**City of West Linn**  
**PRE-APPLICATION CONFERENCE MEETING**  
**Notes**  
**April 4, 2013**

**SUBJECT:** Nine lot subdivision at 22882 Weatherhill Road

Dark lines are 10 foot contour intervals. Light lines are two foot contour intervals

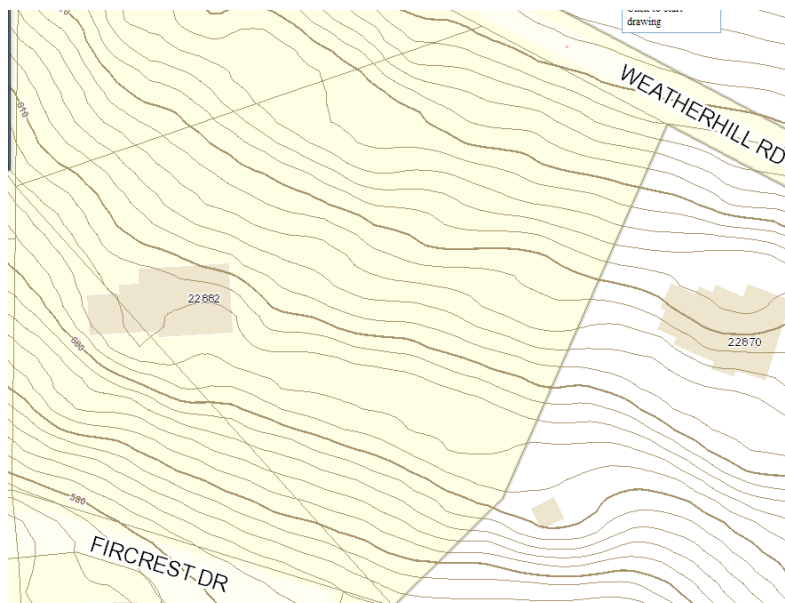
The land drops 60 feet from the north edge of the lot to south edge for an average slope of 16 percent. The slopes worsen south of the existing house with a drop down to the private driveway (extension of Fircrest Drive) of 25-28 percent. These steep sloped areas need to be inventoried. If over 25 percent of the site is over 25 percent then this application needs to be processed as a Planned Unit Development (PUD) in addition to the subdivision application. Although the north portion of the site has less severe grades the applicant should be mindful of the maximum allowable driveway grade of 15 percent. No geotechnical report is required.

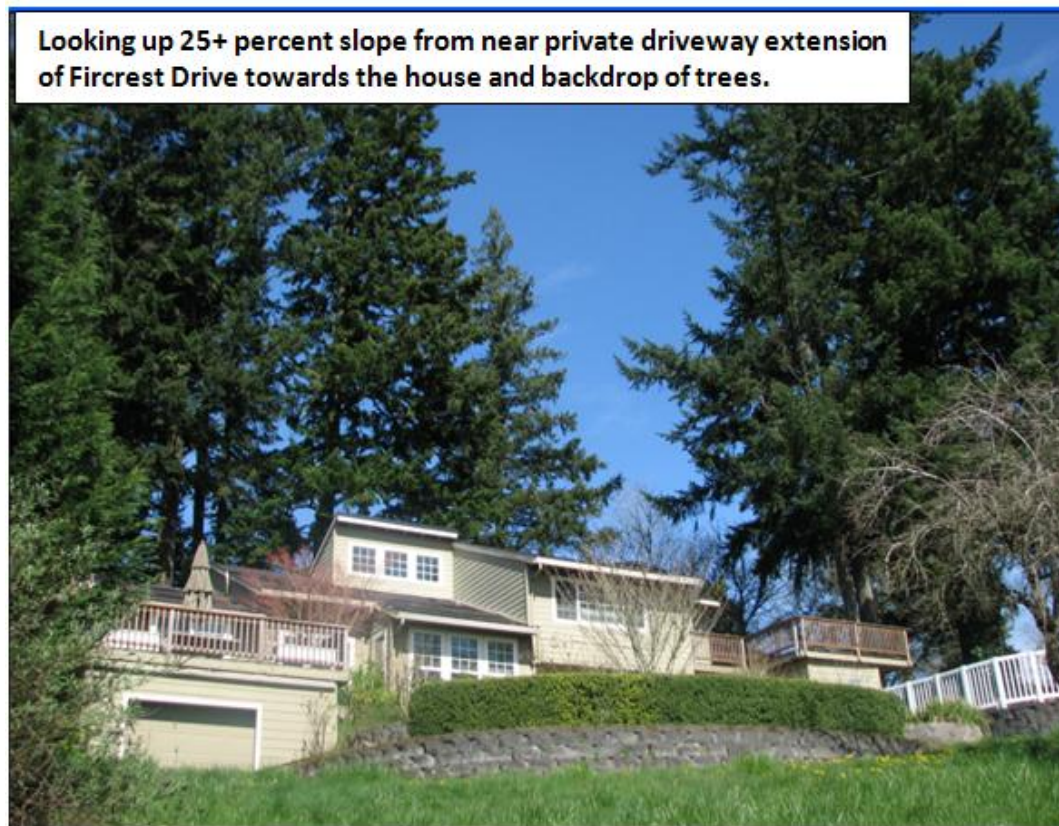
Section 55.100(B)(2) provides for significant tree preservation and can require that up to 20 percent of the non-type I and II lands be set aside for their protection. Significant trees on Type I and II lands are given complete protection. The code makes accommodation for the removal of trees in anticipated street alignments (see 55.100(B)(2) exemptions) but the applicant should anticipate being required to mitigate for their loss on an inch by inch basis exclusive of normal street tree requirements. The mitigation can be on or off-site, or can be satisfied by a fee-in-lieu payment, if the Parks Department agrees to this.

The applicant's arborist should contact City Arborist Mike Perkins (503-723-2554 or [mperkins@westlinnoregon.gov](mailto:mperkins@westlinnoregon.gov)) once the preliminary tree inventory is complete to verify which trees are significant. Generally speaking, the protection of tree groves that can support each other, over individual trees, is preferred.

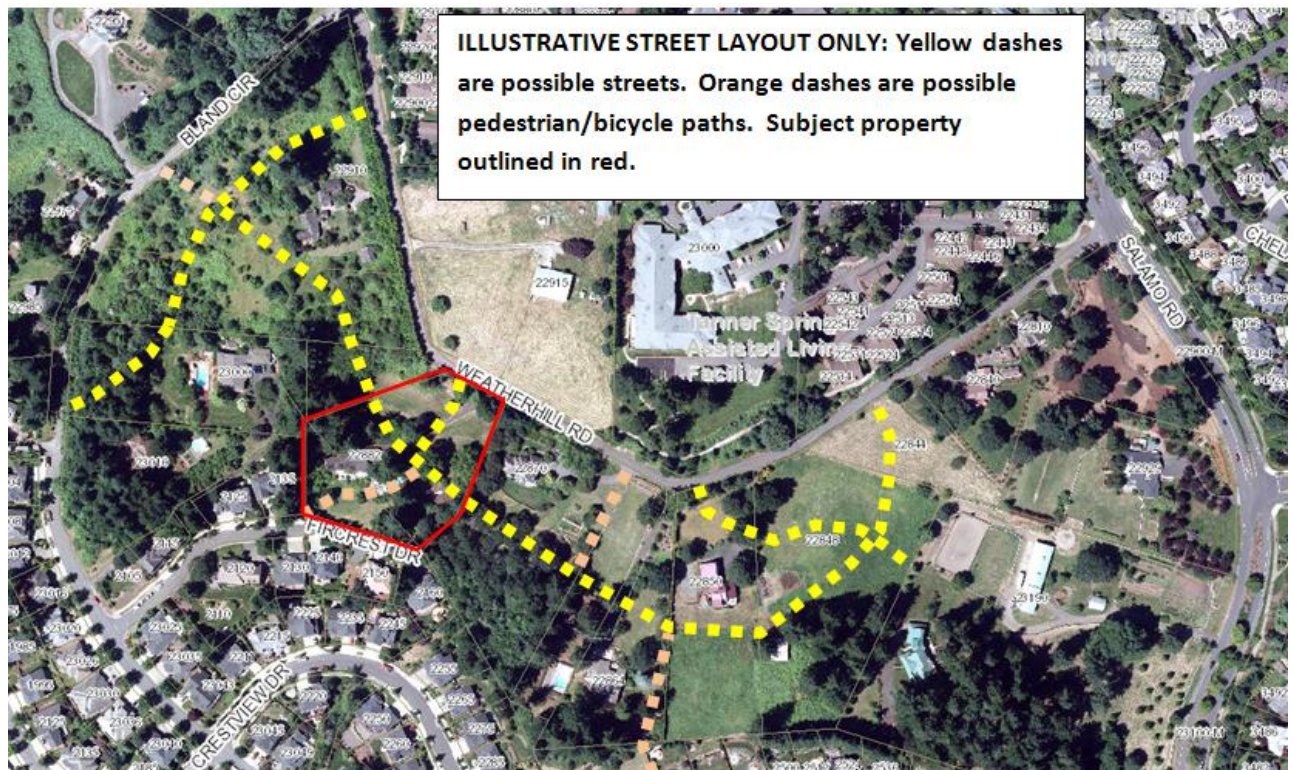
Ideally, the properties south of Weatherhill Road will be connected with a road that runs parallel to Weatherhill Road and prevailing contours about 70-100 feet down the hill so that the internal streets could provide access to lots that would otherwise directly access Weatherhill Road. And, consistent with the functional plan, there would be at no more than 530 feet between driveways or streets intersecting Weatherhill Road. There would be a maximum 800-1200 feet spacing between roads that traverse WRAs and in all cases, pedestrian and bicycle links should be more than 330 feet apart.

It is acknowledged that the applicant may not have control over the development of adjacent or nearby properties or when that development may occur. Nonetheless, the applicant should propose a design that shows a more comprehensive accommodation of the functional plan and the City's approval criteria.

**Staff also discussed the minimum connectivity standard which would require a street stub out to the northwest through tax lot 200 and a 20 foot wide pedestrian/bicycle corridor to the east (tax lot 405). To facilitate these connections, the applicant may propose that interior streets be the minimum street widths per City standards.**
